AP1000 Construction

Translating Technical Requirements and Licensing Commitments into Construction

**Anthony Ponko & Robert Mathis
Division of Construction Inspection**

**Region II
July 28, 2016**

Anchorage and spacing of headed shear reinforcement in structural components of the nuclear island not in compliance with licensing basis (NCV 05200027/2013010-01)

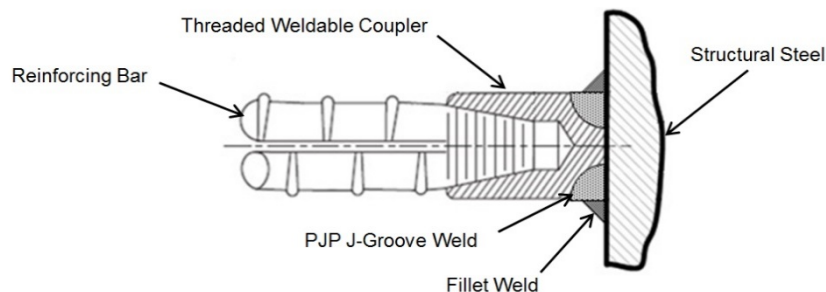
- Bars used to resist out of plane shear forces in slabs and walls
- Typically used to enhance constructability/ alleviate congestion
- Anchorage and spacing not in compliance with Tier 2* code - ACI 349-01
- Bars too short and spaced too far apart to be fully effective

- Adopt alternate acceptance criteria provided in ACI 318-11.
- Revise design as necessary where does not meet ACI 318-11 criteria for headed reinforcement
- LAR (License Amendment 5) required due to departure from Tier 2* information (ACI 349-01)
